Access Compliance Report Public Rights-of-Way (Curb Ramps)

Intersection ID: 25958 Main Street: KINGFISHER_DR Cross Street: PARK_RD Location: NE

ADA ID: C95F467BF11F Ramp Type: PerpDiag Initial Pass/Fail: Fail Overall Compliance: No Severity Score: 33.75

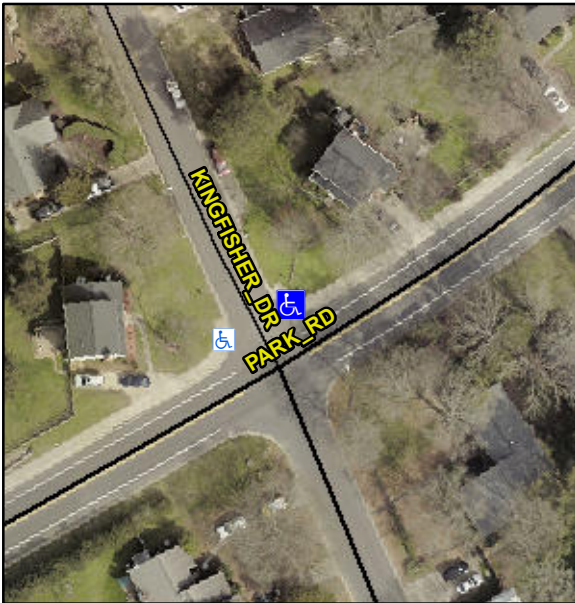
PROW/ADA:
Not Found, R304.5.1, R304.5.3

| Compliance | Description | Data | Compliance | Description | Data |
|------------|-----------------------|------|------------|-----------------------------|------|
| No | Ramp Width (in) | 47.0 | No | Ramp XSlope (%) | 7.9 |

Possible Solutions:
Remove & Replace Curb Ramp With Two New Directional Ramps or Equivalent.
